Mahopac Central School District  
Mahopac, New York

Reconstruction at  
Mahopac High School  
Mahopac Middle School  
Mahopac Falls School  
Bus Garage  
New Pump House

Tt Project No. 121111-19002

### BID Addendum No. 4 to Drawings and Project Manual

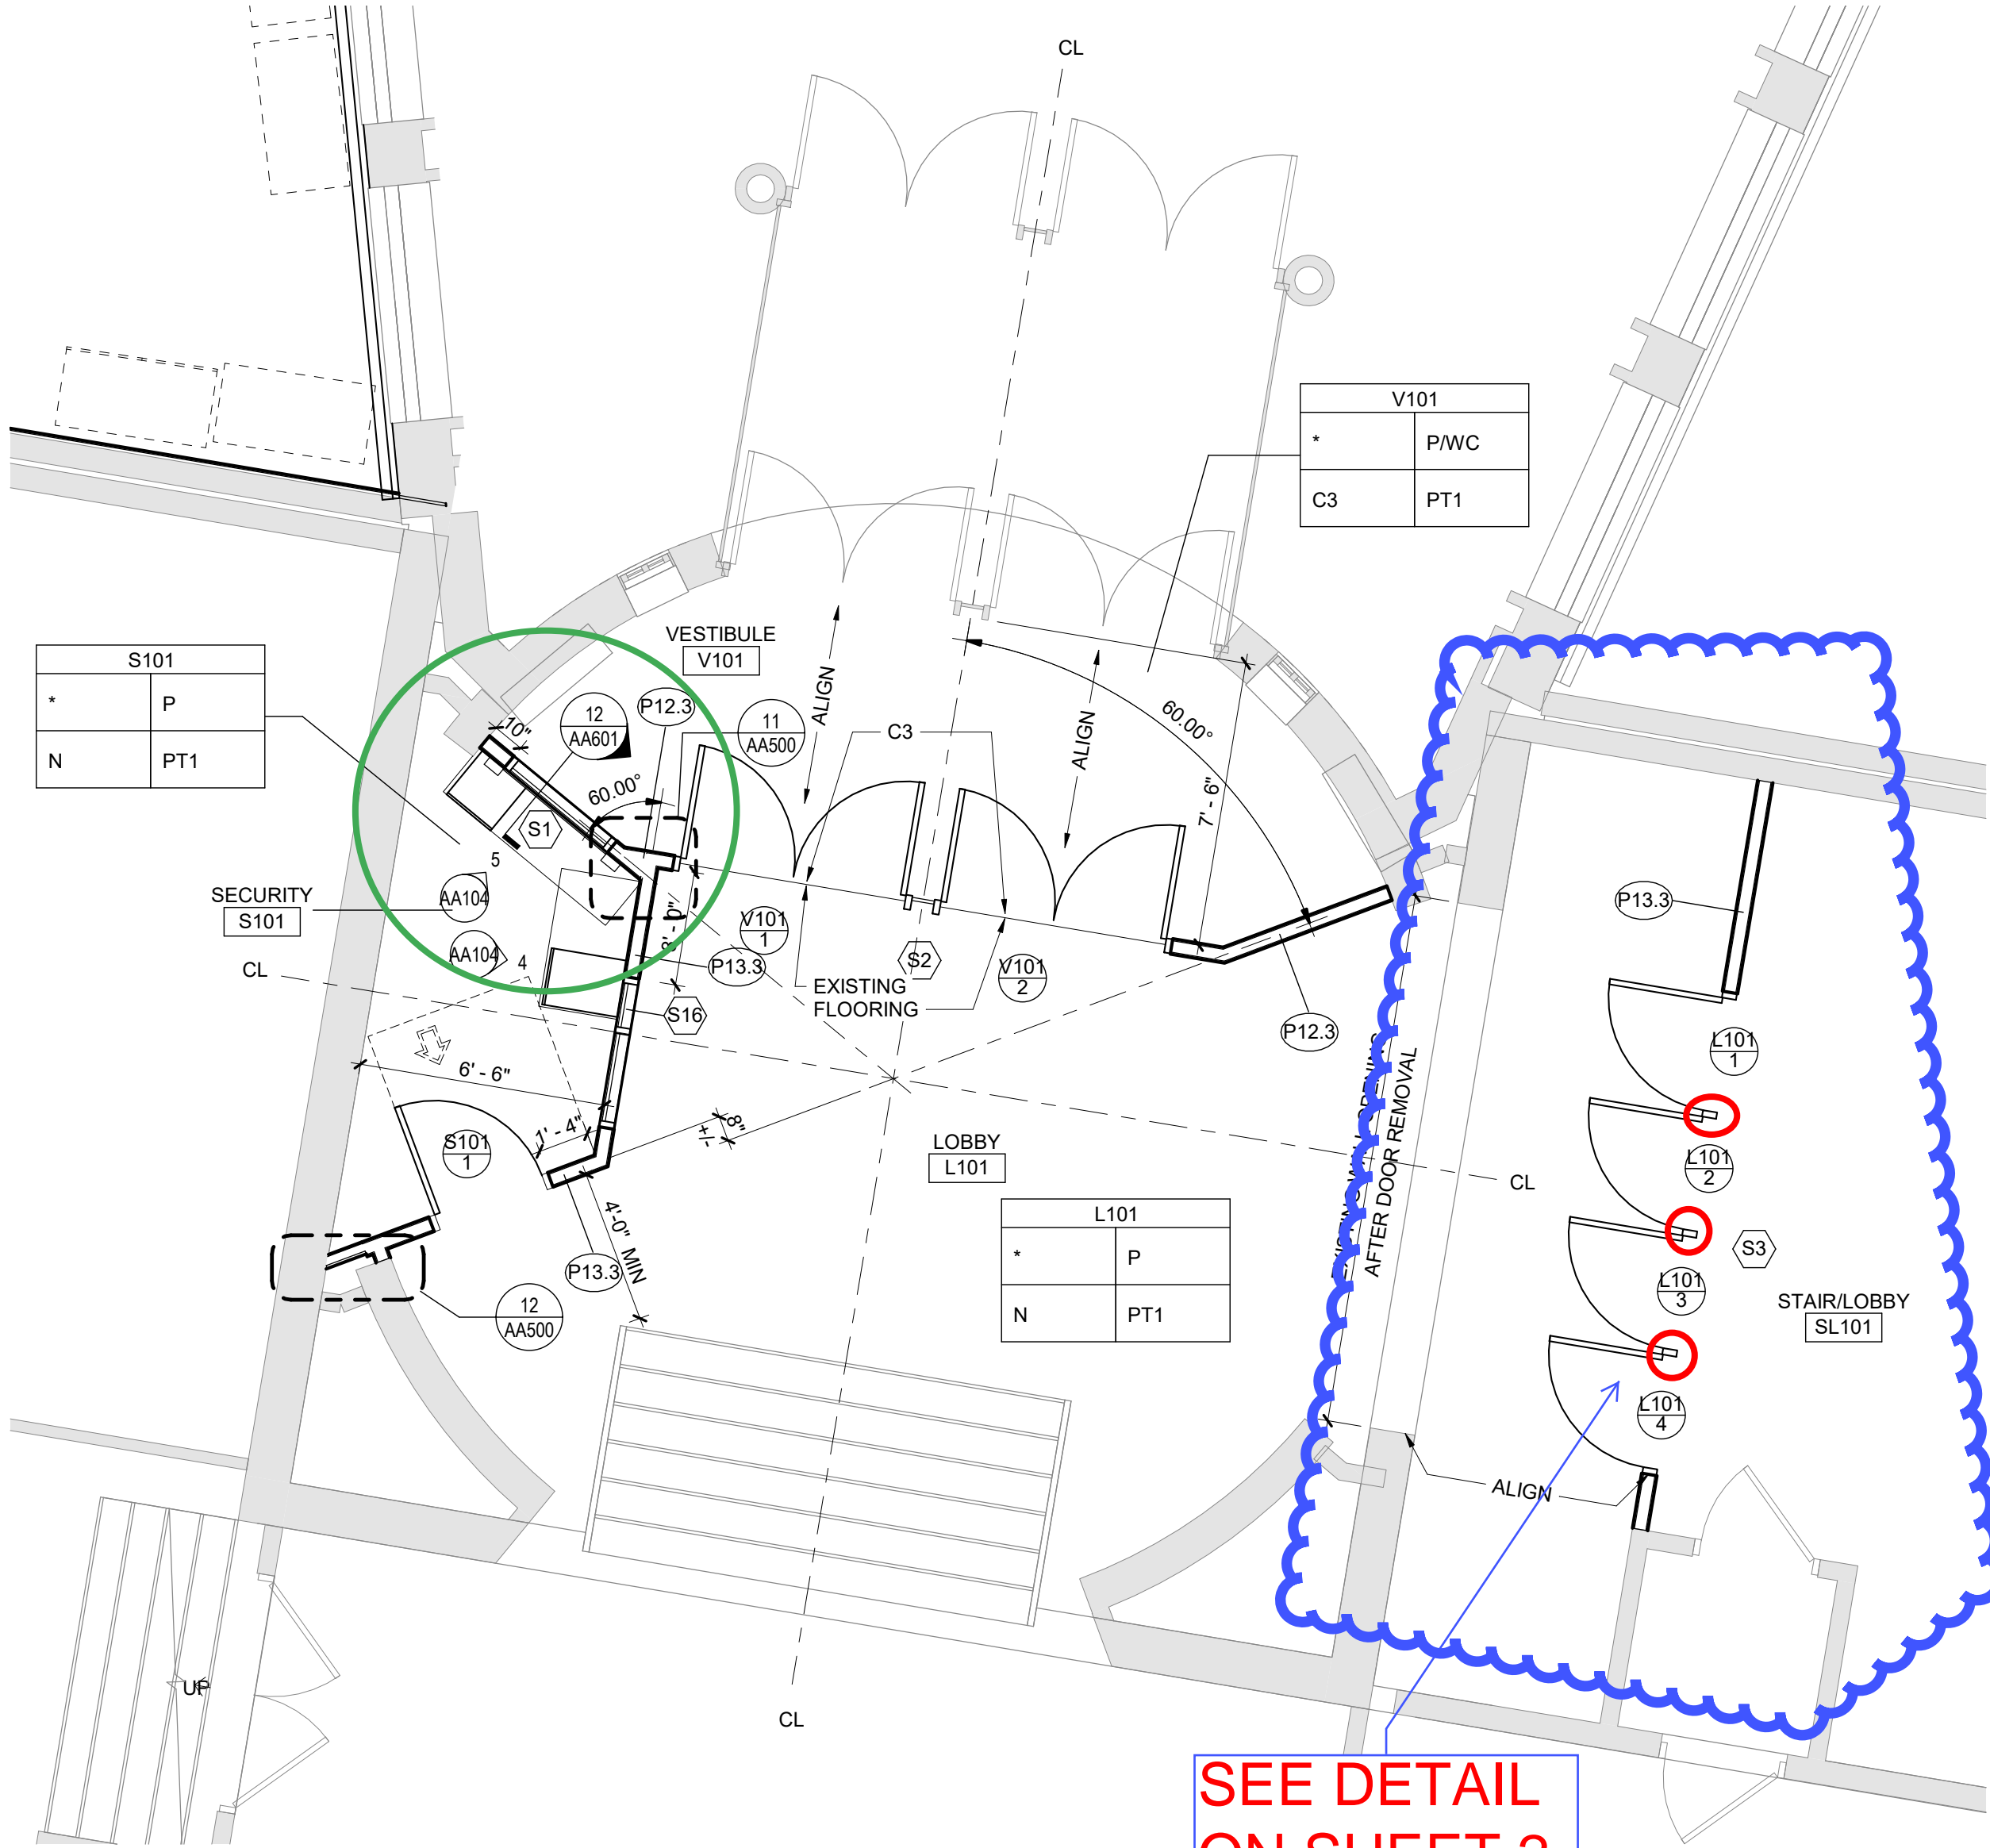
Question from subcontractor bidder :

We would need to use the same full height glass Designer doors as we are using in the other elevations. Also and most important, we need to divide these into 4 separate single door/frame units. These would be separated with either a small section of "wall", or perhaps a steel tube. The steel and any structural calcs if needed would be By Others.

Please advise

2 First Floor Plan - Main Entrance  
1/4" = 1'-0"

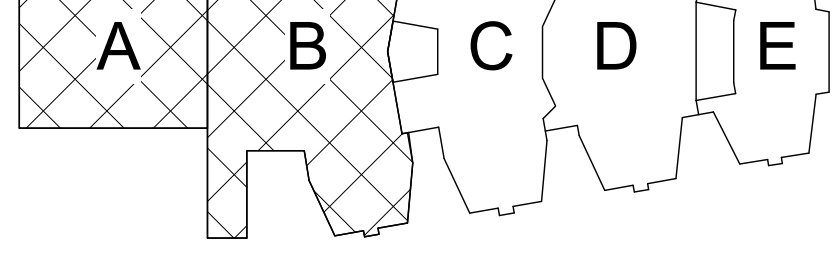
1. Doors L101-2, L101-2, L101-3 & L101-4, AMEND the plan to show 4" portions of Wall Type P13.3 between each of the doors in order to create 4 separate aluminum frame door openings instead of these 4 doors being contained within one frame unit.

1. According to the revised door schedule (sheet AA600) from addendum #1, doors L101-1 through L101-4 (S3's) are "Alum" and 60 min. fire rated. PLEASE CONFIRM.
2. Vendor states that specific door hardware be provided to maintain the tested Fire Rating. This includes Von Duprin Panics, LCN closer, welded on hinges etc. This applies to S3?, S4, S5, and S6.  
Please confirm these deviations from Hardware spec.
3. The door schedule lists Glass Type FPC for doors 242, 243, & 244. However, this is NOT listed in the 088000 Glazing spec. PLEASE CLARIFY.
4. Spec 085653 is for Sliding Security Windows. We cannot find any on the drawings. Is window type S1 (represented as fixed) supposed to be of this type? If not, please advise.

- 1 - S3 doors are 60 min. rated aluminum doors per the documents, additional information will be provided in bid addendum #4  
2 - deviations required to maintain fire ratings are acceptable and will be identified in bid addendum #4.  
3 - FPC glazing is correct for these doors and will be identified in bid addendum #4  
4 - will be clarified in bid addendum #4
